On June 13, 1983, Sunedco Coal Company submitted a number of revised pages to be inserted into the Mining and Reclamation Plan (MRP) for the Sage Point-Dugout Canyon Project. These revisions were made in response to issues discussed in a joint meeting between OSM, DOGM and Sunedco Coal Company on June 1, 1983. The issues raised at this meeting related to the stipulation list for the Sage Point-Dugout Canyon mining and reclamation plan approval. The applicant was asked to provide additional information in the MRP so that both the number and scope of stipulations could be reduced. This Addendum to the Technical Analysis evaluates Sunedco's June 13, 1983 MRP changes and documents the rationale for the resulting changes to the stipulation list originally generated by DOGM's Technical Analysis.

1/ This technical analysis addendum was prepared by the Utah Division of Oil, Gas, and Mining in July 1983 on Sunedco's proposed life-of-mine permit application (40 yrs. - 18,242 acres). All references herein to the permit area or mine plan area refer to the life-of-mine. In December 1983, Sunedco revised this PAP to include only 4,475 acres in the initial permit area. Accordingly, portions of t

Map 1 - Fish Creek Raptor Nest Sites

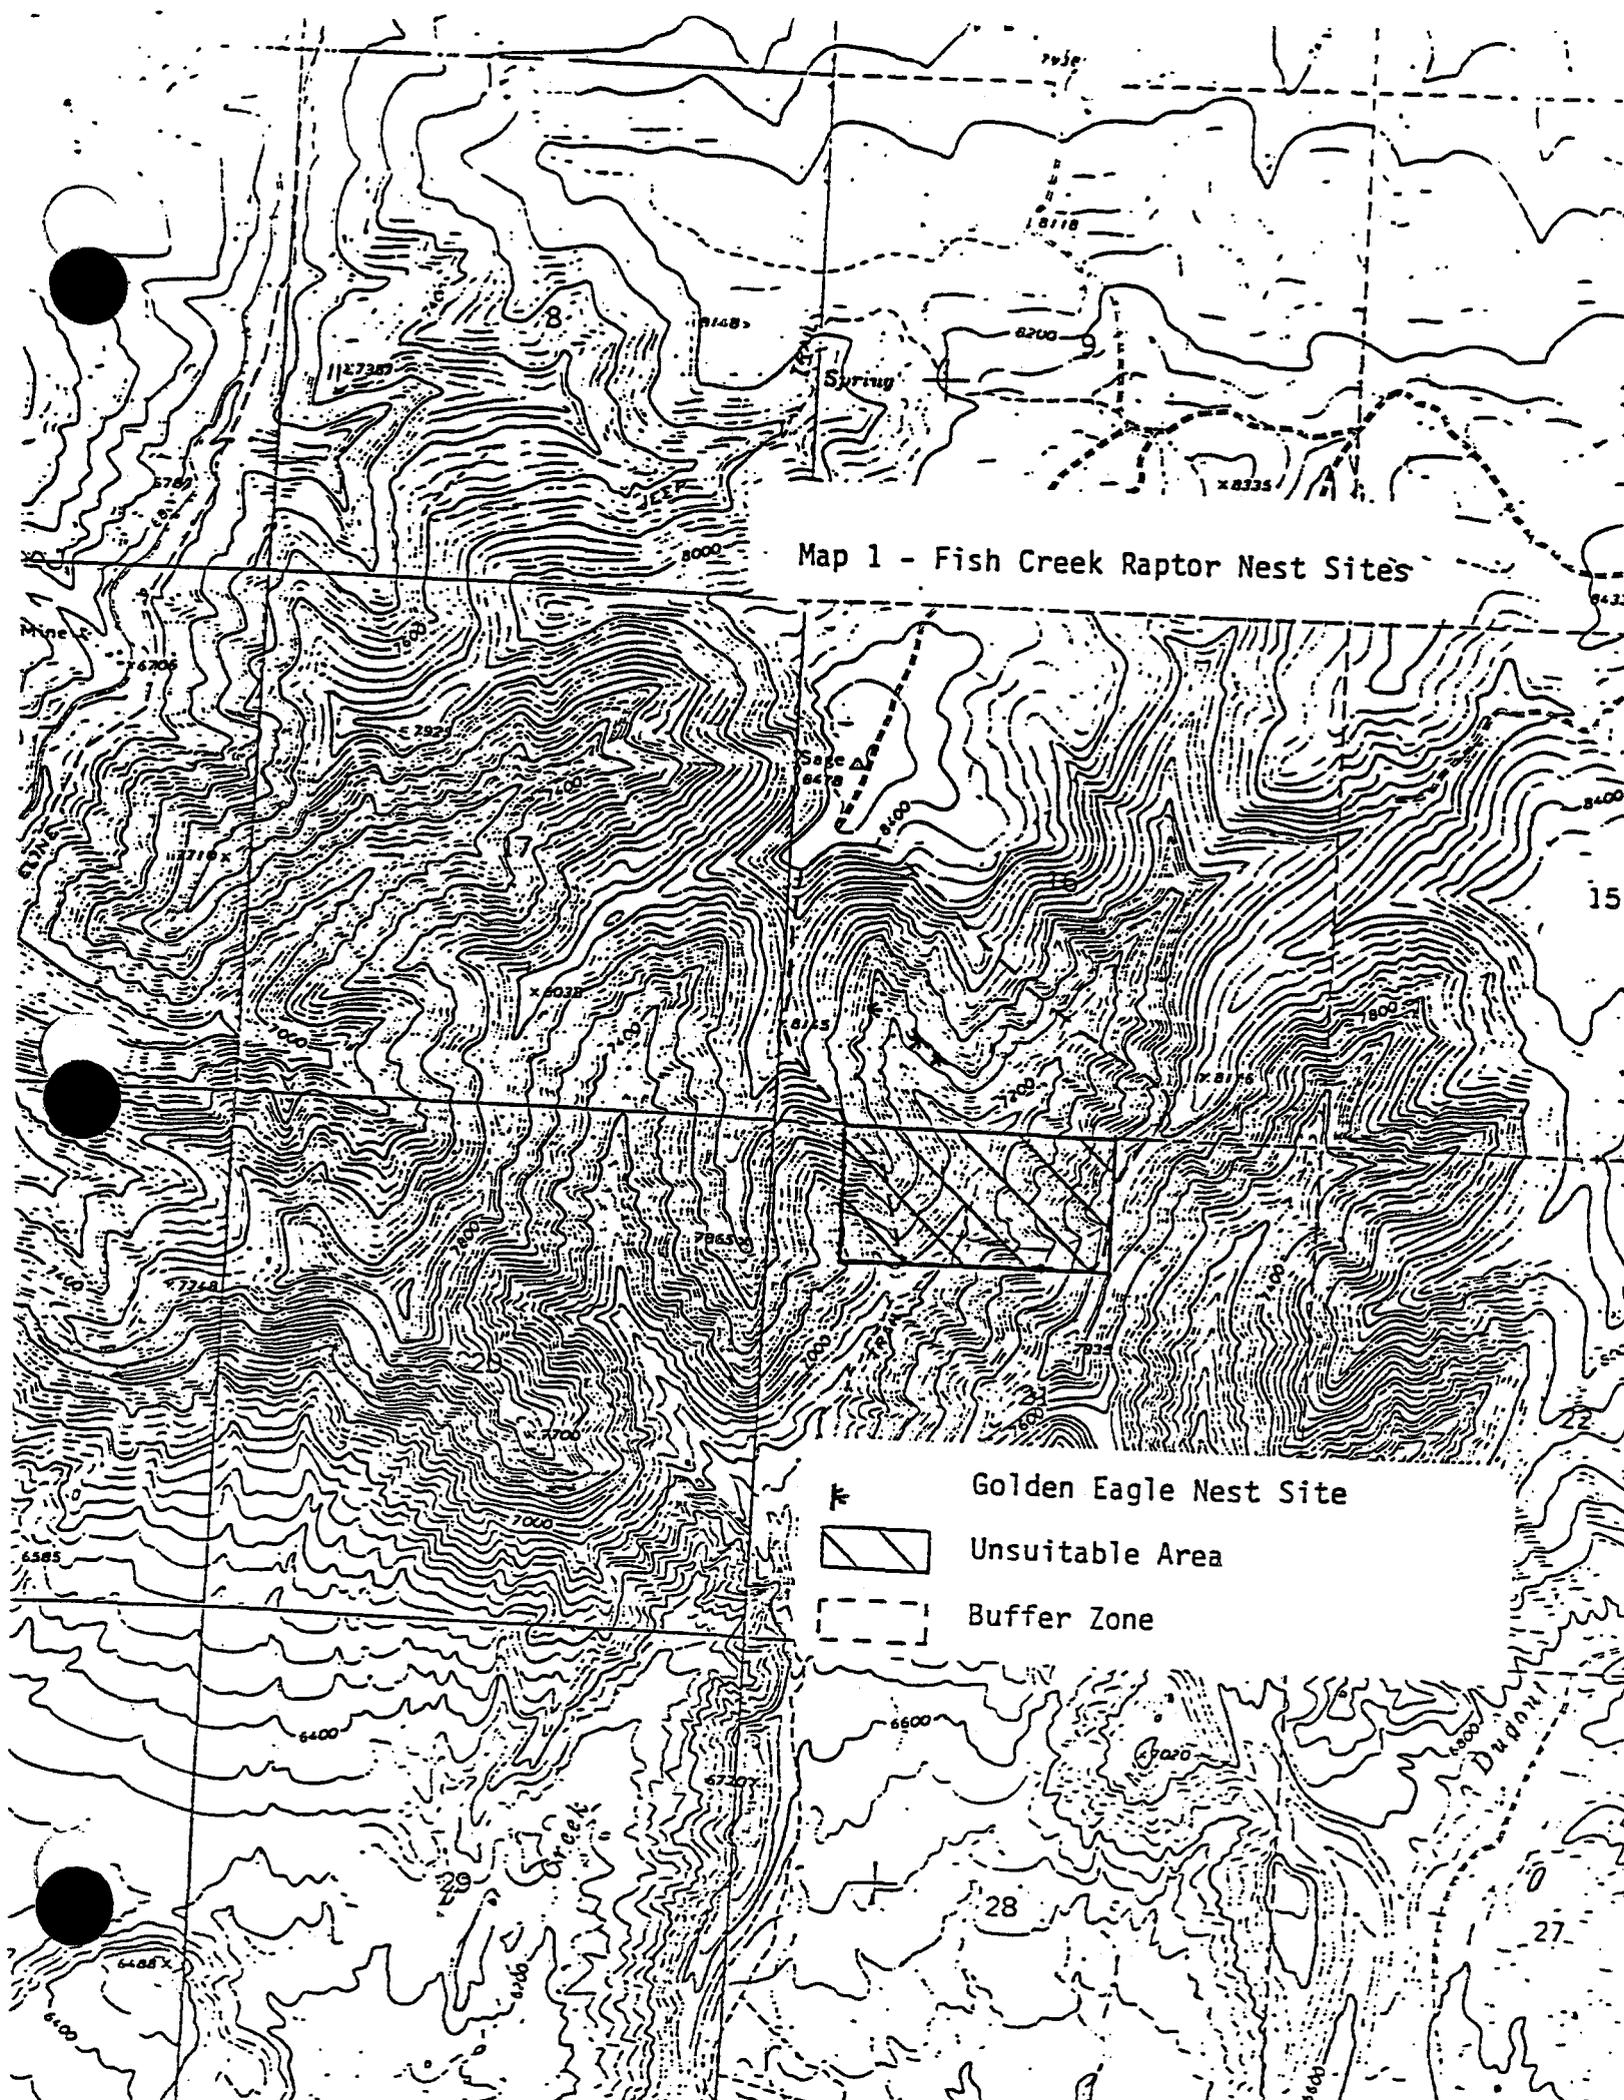
- D. Construct surface facilities in Fish Creek Canyon as shown on the attached drawing (figure 1). Place topsoil and revegetate the retaining wall (shaded in on figure 1) with trees, shrubs and understory species. Where possible, use fullsize native trees and shrubs which are in areas to be disturbed. This will act as a visual block for activity in the parking area and for traffic along the portal road. Specific requirements for this revegetation will be provided to the company at the time of development.

Map 2 - Dugout Creek Raptor Nest Sites

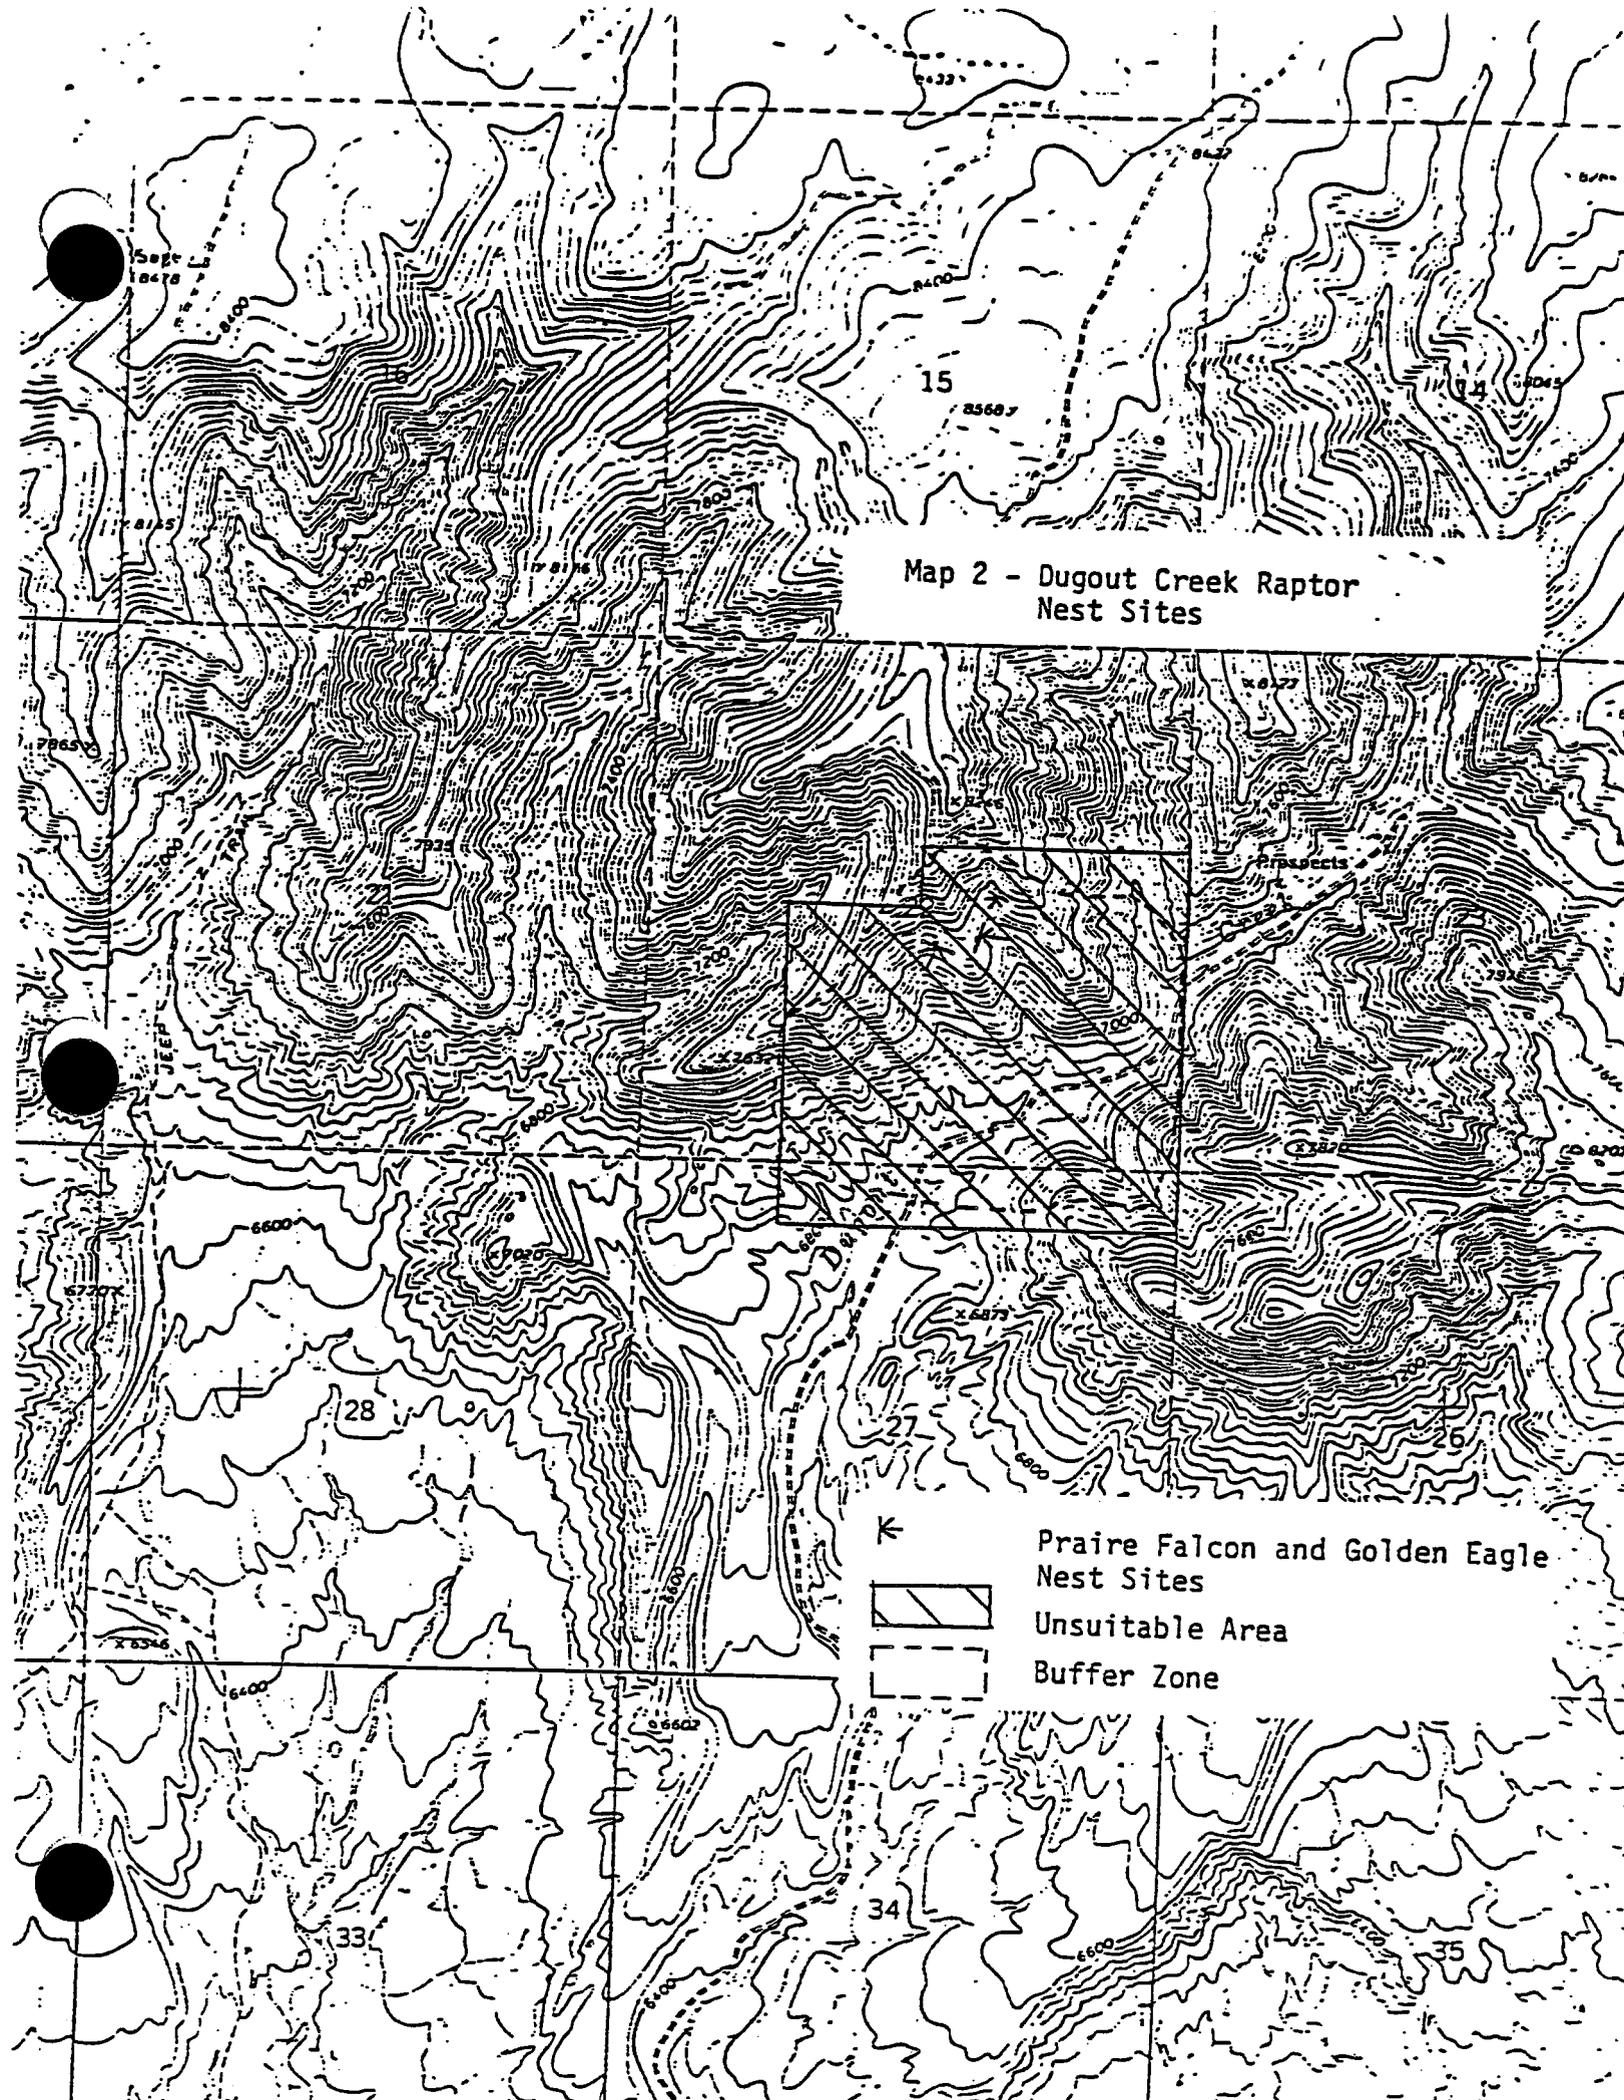
- A. Allow construction of conveyor belt alignment (Alternative 6) as shown in figure 2, in Dugout Canyon.
- B. Shield all lighting of the conveyor belt within the buffer zones in Dugout Canyon to minimize visibility of these lights from golden eagle and prairie falcon nest sites.
